# PIC18F87J50 FAMILY

## PIC18F87J50 Family Silicon Errata and Data Sheet Clarification

The PIC18F87J50 family devices that you have received conform functionally to the current Device Data Sheet (DS39775B), except for the anomalies described in this document.

FIGURE 19-10: I<sup>2</sup>C™ SLAVE MODE TIMING (TRANSMISSION, 7-BIT ADDRESS)

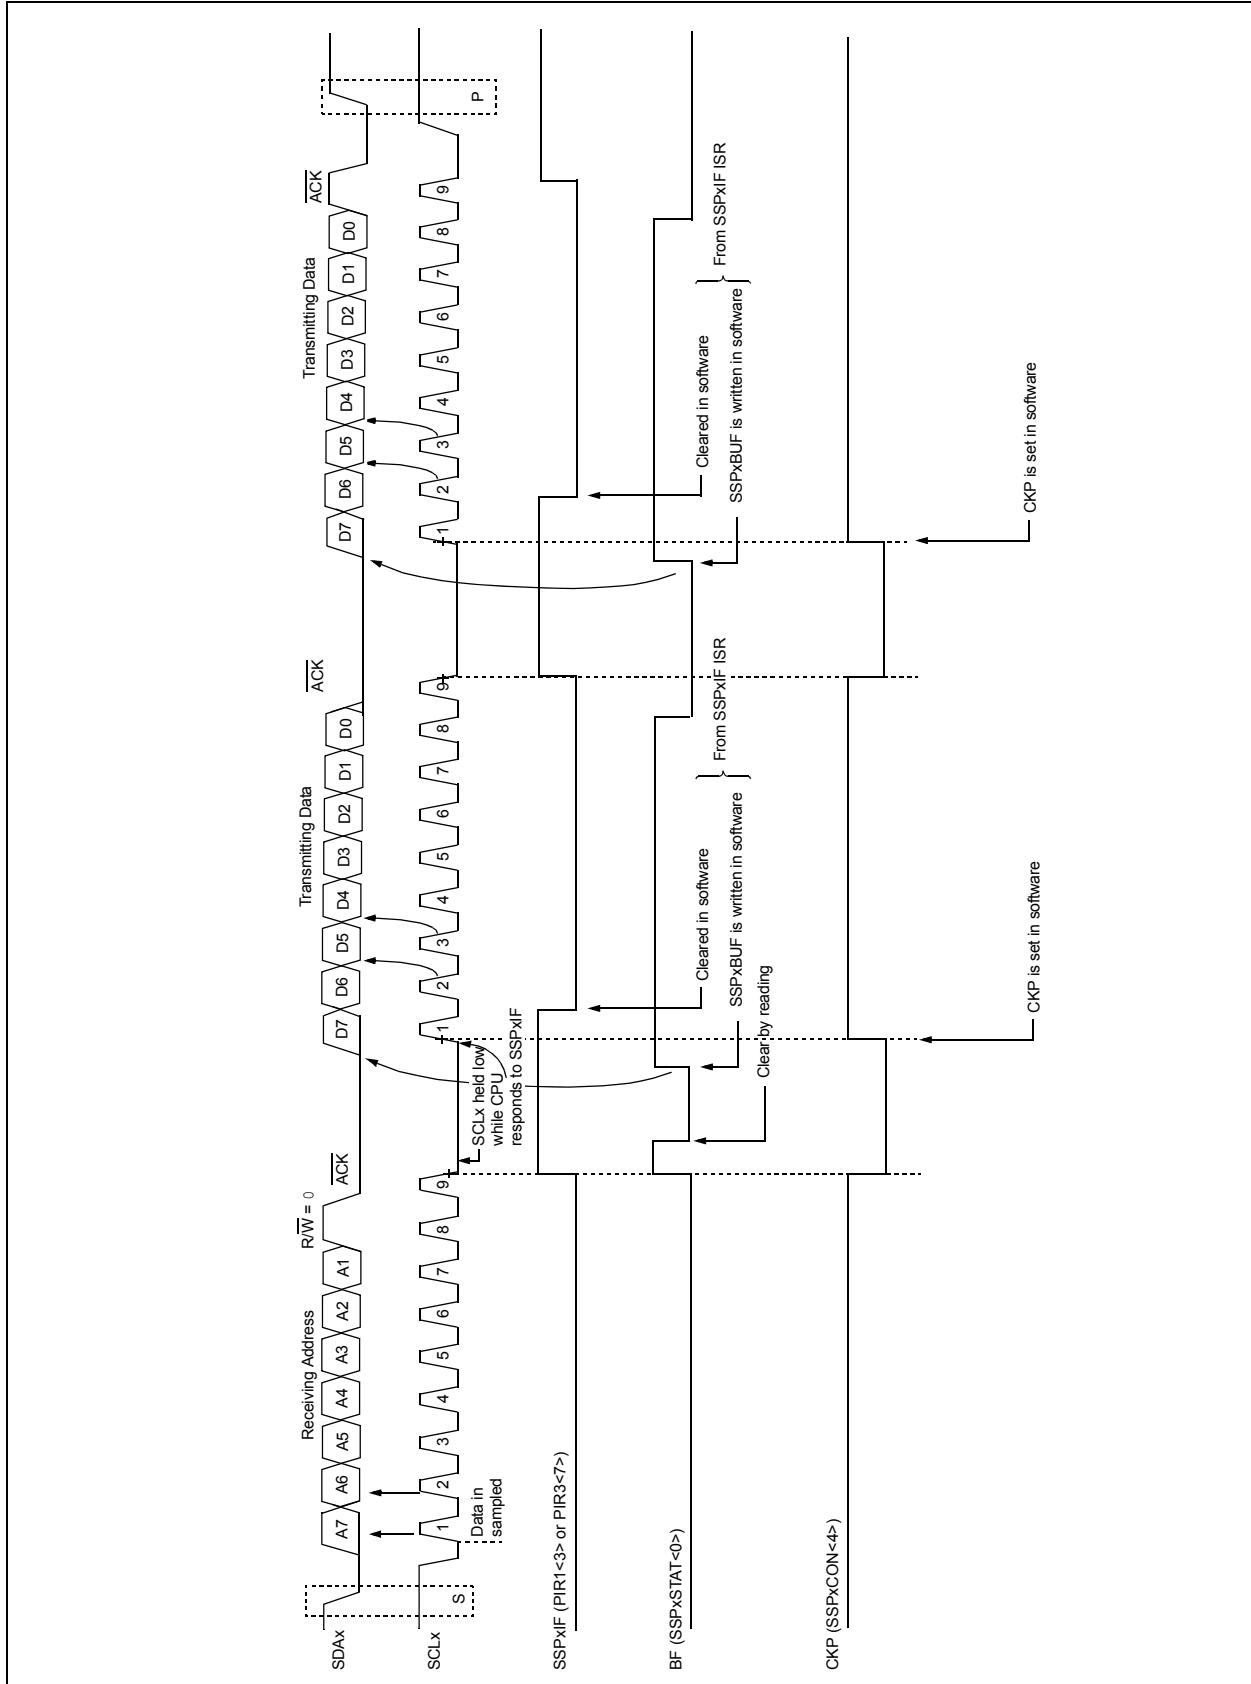
## 6. Module: Figure 19-10: I<sup>2</sup>C™ Slave Mode Timing (Transmission, 7-Bit Address)

On page 252, the figure is replaced with the new timing diagram provided in Figure 19-10.

**FIGURE 19-24: I<sup>2</sup>C™ MASTER MODE WAVEFORM (RECEPTION, 7-BIT ADDRESS)**

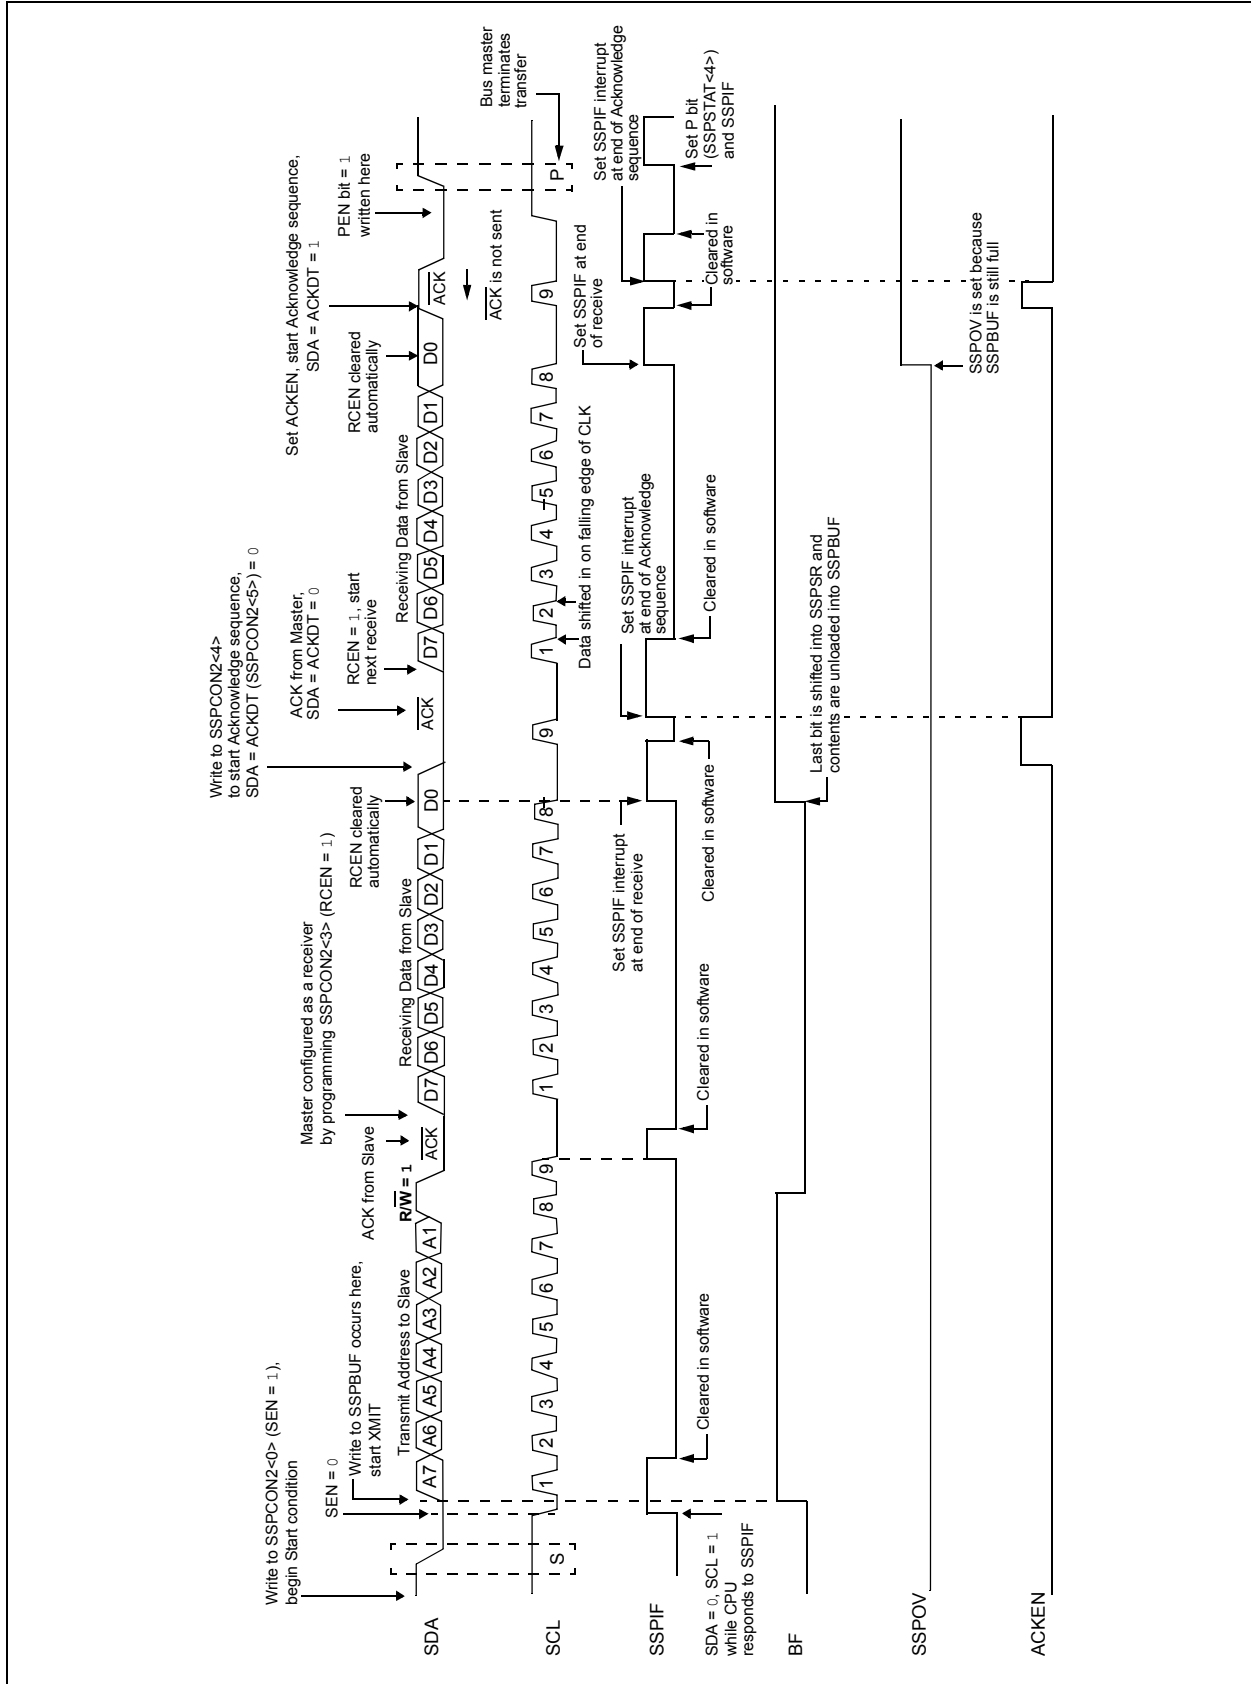
## 7. Module: **Figure 19-24: I<sup>2</sup>C™ Master Mode Waveform (Reception, 7-Bit Address)**

On page 269, the condition,  $R/\overline{W}$ , when the Acknowledge signal (ACK) is received from the slave, after transmitting the address to the slave, is changed to '1'.

The changed value is indicated in bold text in Figure 19-24.
